PUBLIC HEARING MEMORANDUM

SUBJECT: **Petition #59-21**, for SPECIAL PERMIT/SITE PLAN APPROVAL to allow four single-family attached dwelling units in two structures, and to reduce side and rear setback requirements at 1092-1094 Chestnut Street, Ward 5, Newton Upper Falls, on land known as Section 51 Block 41 Lot 04, containing approximately 20,291 sq. ft. of land in a district zoned MULTI RESIDENCE 1. Ref: Sec. 7.3.3, 7.4, 3.4.1, 3.2.4 of the City of Newton Rev Zoning Ord, 2017.

MEMORANDUM

Re: Special Permit – 1092-1094 Chestnut Street

Proposed Site Plan

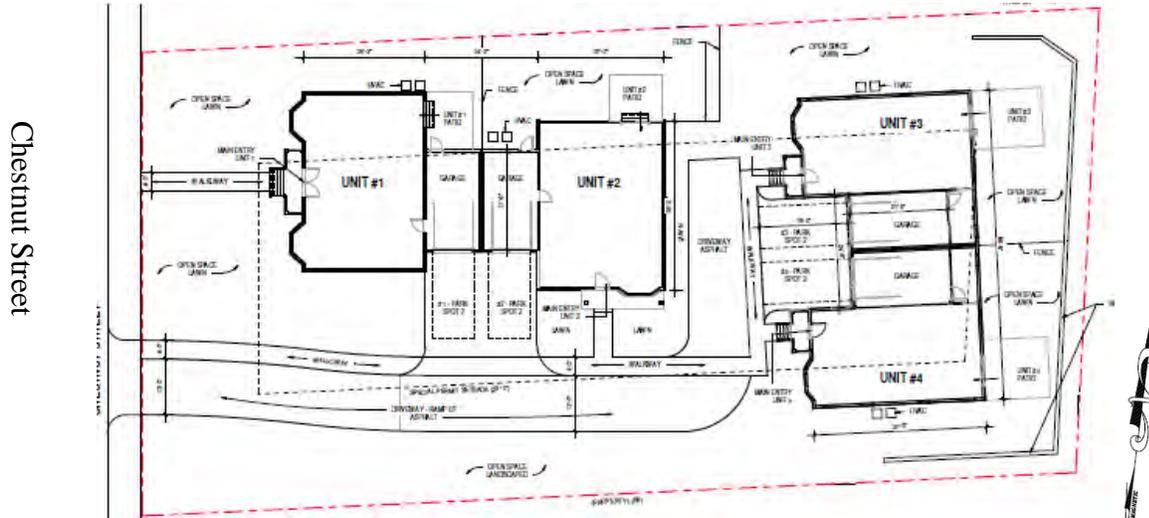
The entire year yard contains a retaining wall. The wall reaches a maximum height of 3.9 feet and allows for level patio and rear yard space for the units in Building 2. Planning Staff noted that air conditioner condenser units are proposed within the setbacks. Air conditioning condensers units must meet principal building setbacks.

System #1 (As designed)

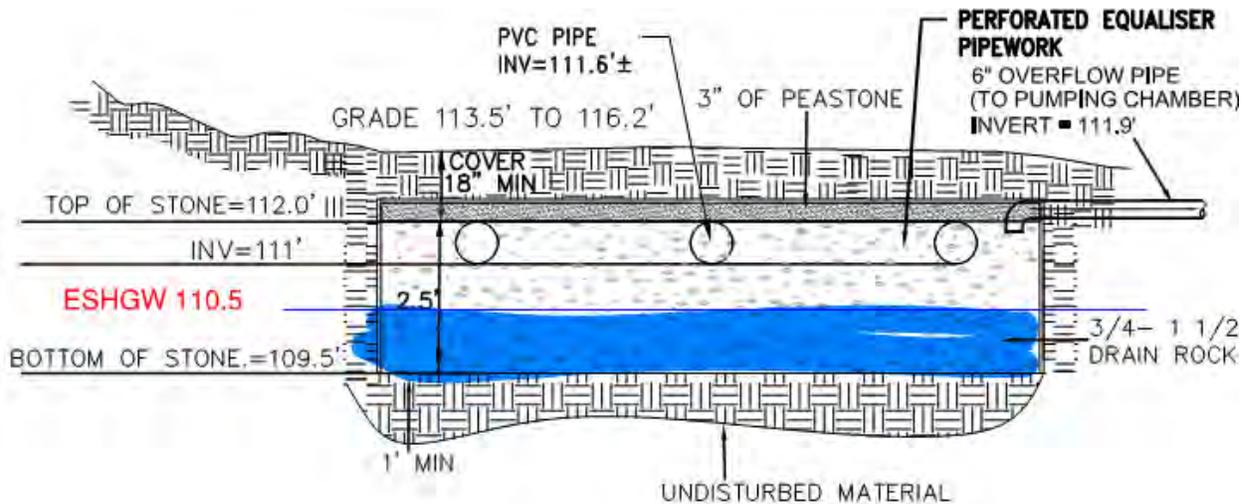
The engineer of record has designed a stormwater collection system to capture runoff from the proposed driveway and roof areas for the City 100-year storm event; however, based on the soils tests conducted on January 27, 2021 the estimated seasonal high groundwater (ESHGW) elevation is 3 feet below grade; the ESHGW during the Spring months may possibly be higher.

Each residential unit has been outfitted with sump pumps that are to discharge to on-site infiltration system which also have an overflow to the City's drainage system. My concern with the design is that the two proposed infiltration fields are set within this ESHGW elevation, rendering the systems to be submerged at certain times of the year when ground fluctuates.

System #1 will have the bottom 1 foot in this zone and System #2 will have 2 feet within the groundwater, the system is not functioning at full design capacity (i.e., storage since they will be partially full of groundwater) loss of volume storage. Both systems should be elevated a minim of 2 feet above the ESHGW elevation to be effective. The proposed overflow pipe should be made at the drain manhole in lieu of its proposed location.

Once the systems have been adjusted, calculations for infiltration are needed in addition to demonstrating as required by the DEP that the systems will be fully drained (emptied) within 72 hours after a storm event. An Operations and Maintenance (O&M) plan for the long-term maintenance of the proposed stormwater management facilities needs to be drafted and submitted for review. Once approved the O&M must be adopted by the applicant/property owner, incorporated into the deeds; and recorded at the Middlesex Registry of Deeds. A copy of the recording instrument shall be submitted to the Engineering Division.
